MUIR WOODS SUBDIVISION, FIRST UNIT, RE-SUBDIVISION AND ADDITION TO LOT 10

APPLICATION NUMBER 7 DATE September 7, 2017
 APPLICANT Muir Woods Subdivision, First Unit, Resubdivision and Addition to Lot 10
 REQUEST Subdivision

DETAIL SITE PLAN

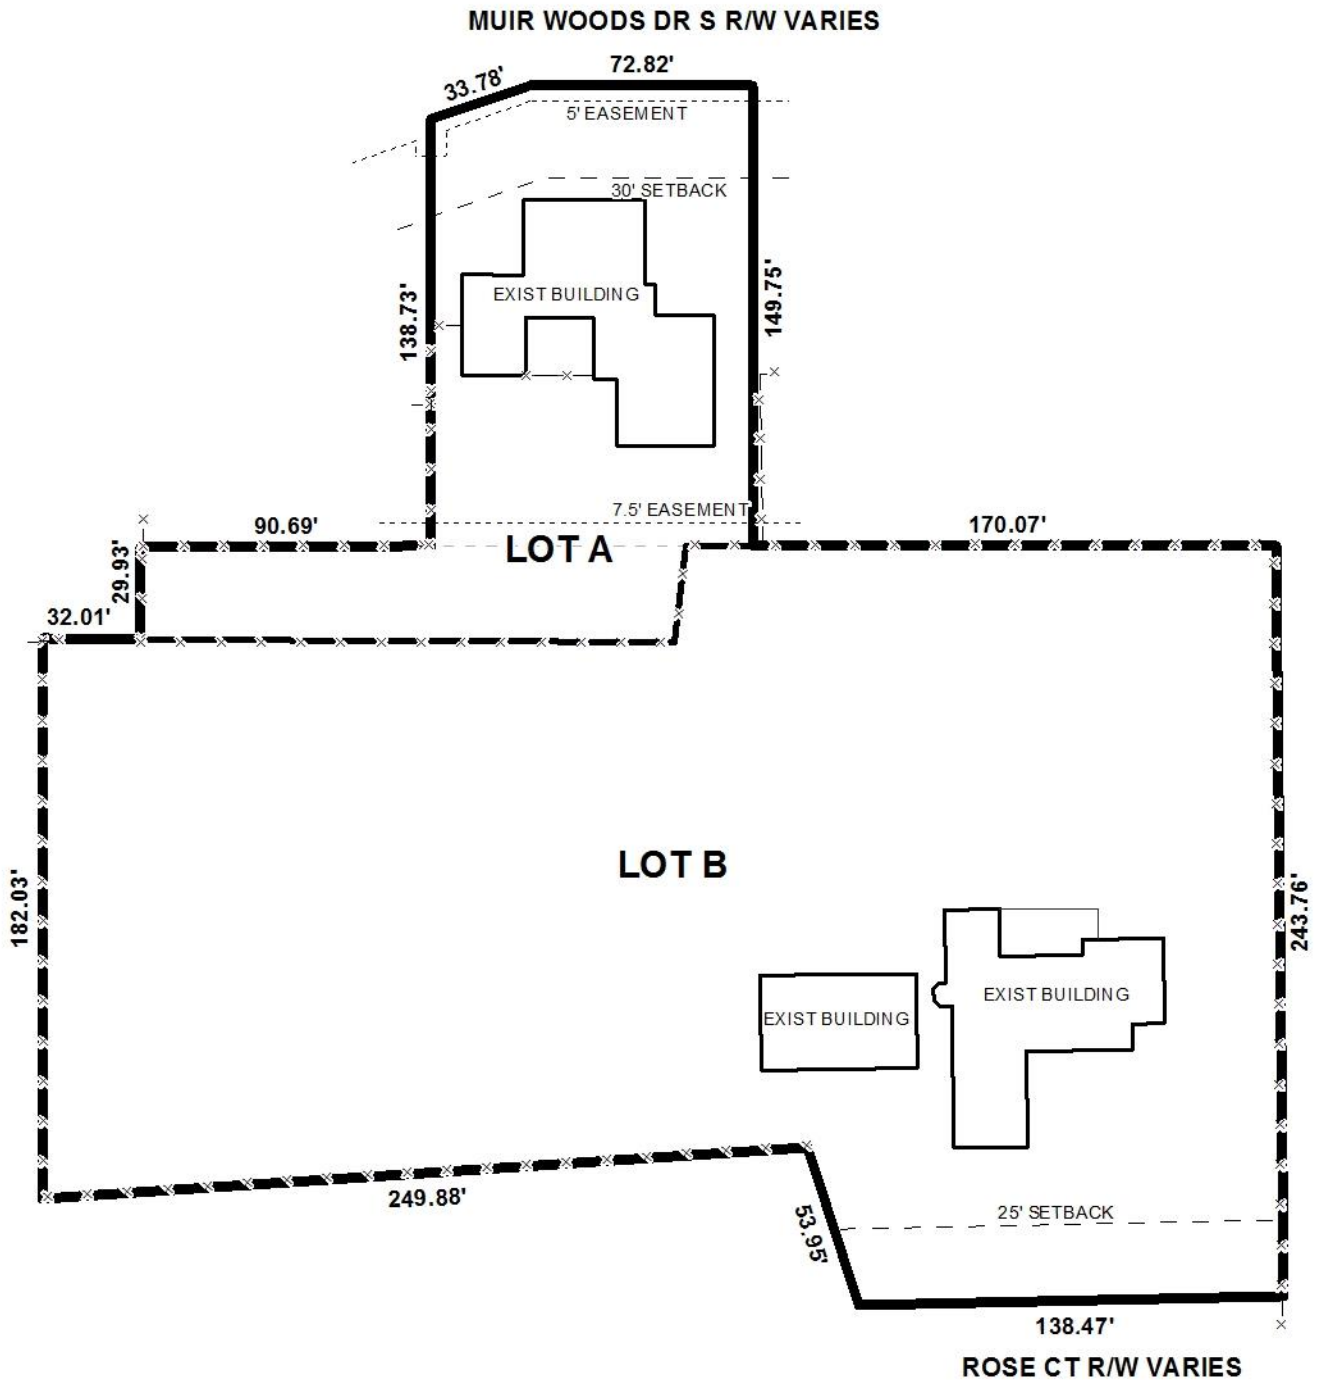
Lot A has frontage on Muir Woods Drive South, a minor street with curb and gutter requiring a 50' right-of-way width. Lot B has frontage on Rose Court, an unpaved minor street without curb and gutter requiring a 60' right-of-way width. The plat illustrates sufficient right-of-way along Muir Woods Drive South, but not along Rose Court; however, dedication was not previously required in 2006 or 2012 and, as such, it should also not be required for the request at hand.

Both lots are irregularly shaped, but nevertheless meet the minimum size requirements of the Subdivision Regulations for lots served by public water and sanitary sewer. Their sizes are appropriately labeled in square feet and acres on the preliminary plat and, if approved, should be retained on the Final Plat; or, provision of a table providing the same information should suffice.

The required 25' minimum building setback line is illustrated along Lot B, and a 30' minimum building setback line is illustrated along Lot A; both of which should be retained on the Final Plat, if approved.

A 5' utility easement and 7.5' drainage and utility easement are illustrated along the front and rear portions of Lot A, respectively. As such, if approved, a note should be required on the Final Plat stating no structures shall be built in any easement.
